**PB# 92-28**

**Windsor Crest (Hilltop)  
(Amended SP)**

NAME: AMENDED SITE PLAN II - WINDSOR CREST CONDOMINIUMS  
APPLICANT: NEW HILLTOP DEVELOPMENT CORP.

SUBJECT: WINDSOR CREST (HILLTOP) SITE PLAN  
NEW WINDSOR PLANNING BOARD NO. 92-28 Copy in #86-89  
MHE JOB NO. 87-56

PAVEMENT TYPE I  
NOT TO SCALE

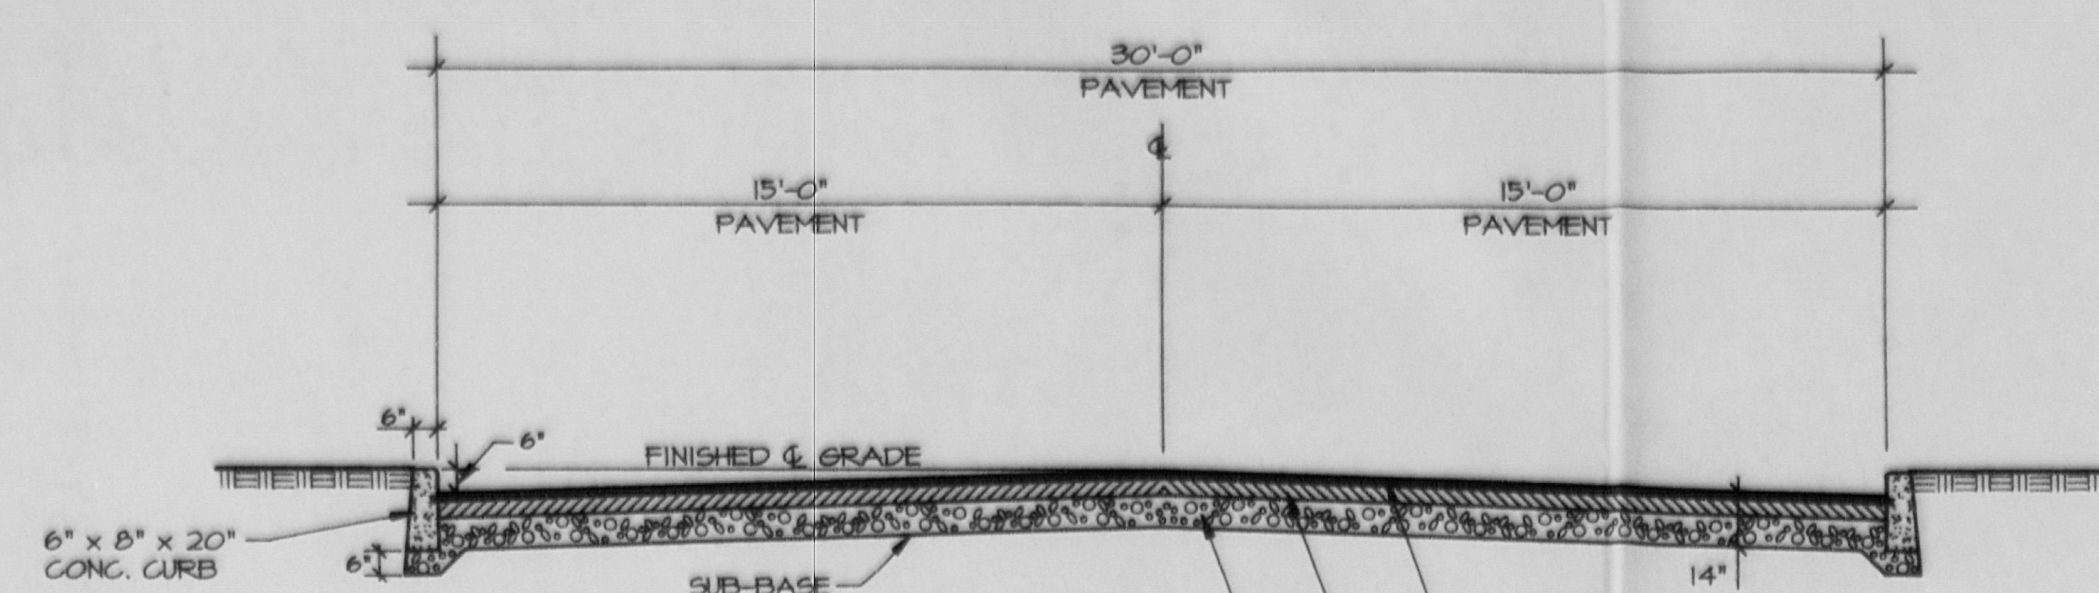
BY MR. SHAW: Before you is an amended site plan number two and what that amendment does, it designates three different pavement types and immediately above the plan is a cross section of the three pavement types. What we are proposing both road A south and road A north to go with pavement type one.

and Road A north pavement type one which is as your run-a-bank gravel with four inches of binder, two inches of top and that that pavement composite is consistent with the town road specifications. Again that is for road A south and road A north. We are proposing for the spurs which are the parking areas in front of the units to the north, they would be units one through six and on the other side of the site they would be for units 21 through 26 pavement type two which is two inches of binder and one inch of top, three inches of macadam pavement. That is not a very heavy --

PAVEMENT TYPE IIA  
NOT TO SCALE

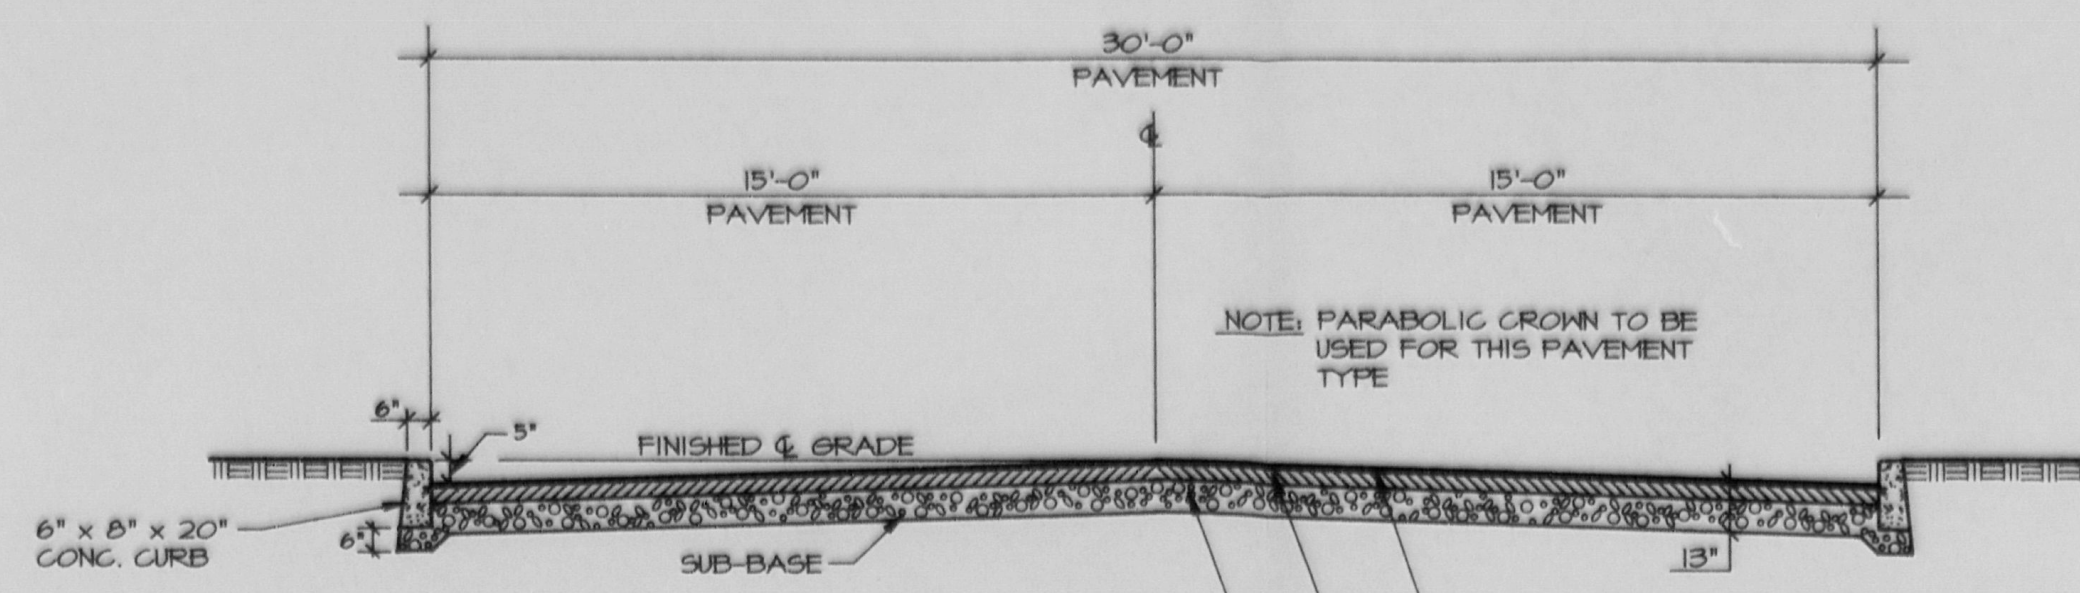
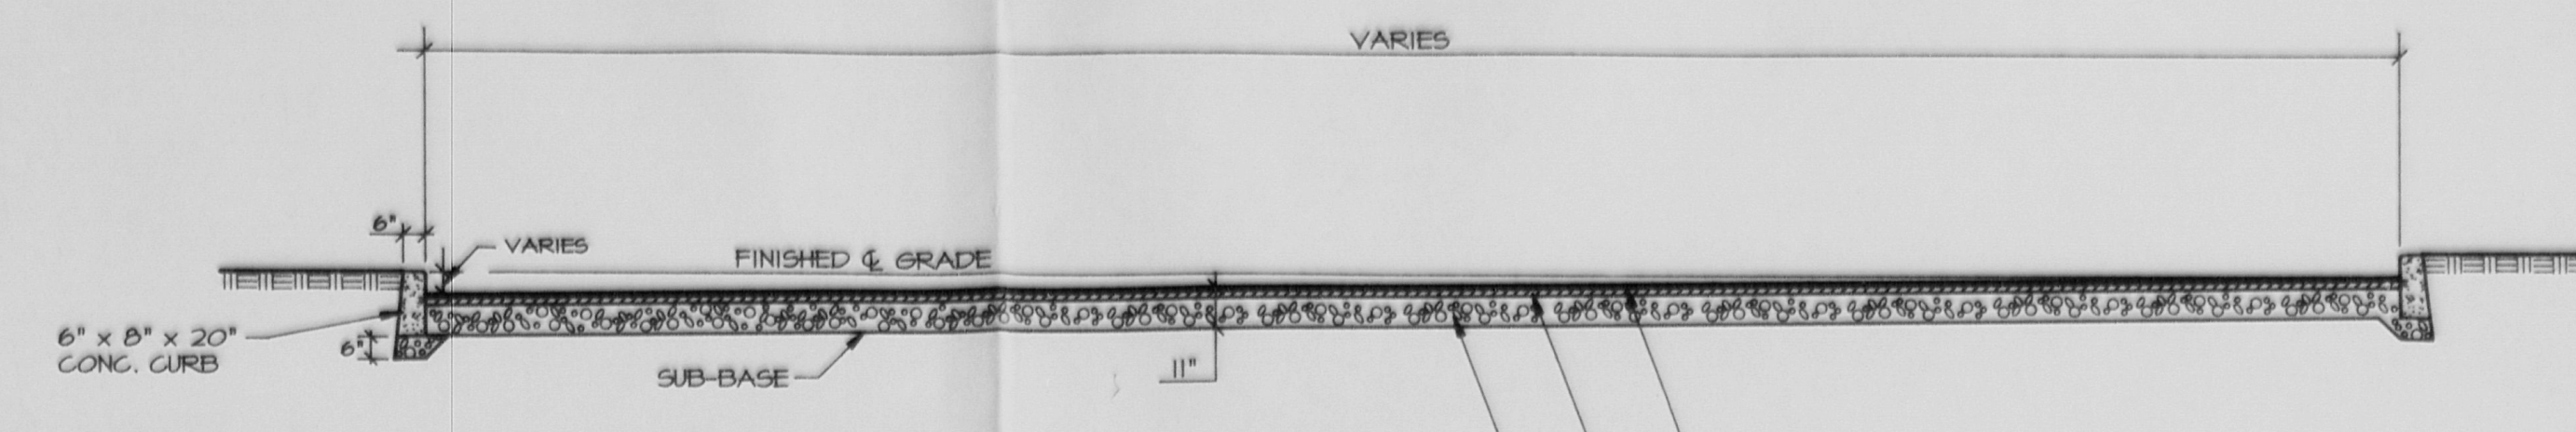
BY MR. SHAW: For a total of three. And the last pavement type will be pavement type two which would be for road B and I believe that is where the issue lies with this Board. What we are proposing is a total of five inches of macadam pavement presently right now there's only binder. I believe there's approximately two inches of binder. We are proposing to install three more inches. There'd be another two inch lift of binder and one inch of topping. That road at your request was looked at by the paver and I believe he submitted a letter to the Board stating that using parabolic crown of the paving that he could get five inches of macadam on that road and still maintain the reveal of the curb.

BY MR. LANDER: Which would be a total of four more or less. I don't have the sheet in front of me but I think it's mostly less but how are we going to put, it says here put three more inches on top of this road in total now cause you're going to put two more inches of binder and you're going to put one inch of top over the whole road and I know what a parabolic crown is and the reveal at this point was eight inches, well, to get six inch reveal you can't put three more on it so I haven't seen that letter yet. I wasn't privy to that. So I don't know how you're going to accomplish that, put three more on there and come out not being higher in the center of the road than the curb.

BY MR. KELLY: They just asked me to say that it can be done, not with three inches at the curb. If you left two inch reveal, two inch extra pavement at the curb and then built up as you went, description I had of it was that the crown would have to be higher than what is normally required.

BY Mr. SCHIEFER: Can I make a comment? I'll make a motion to approve this. This is not a motion but I'm willing to make a motion to approve this the way it is on the map with the sole exception of five inch reveal rather than six. However, if this is not done, if you come before the Board for anything else before phase two, I don't care what it is, it's going to be no. It's got to be to the way that map is. I'm not going to back off again. We have backed off twice. If the applicant accepts that, I'll make the motion to accept the modified site plan and the changes on the road B in accordance to this drawing, with the exception of the reveal on road B alone can be five inches.

BY MR. PETRO: Motion has been made to approve the Windsor Crest site plan for road B pavement according to the detail on the map except five inch reveal for road B only.
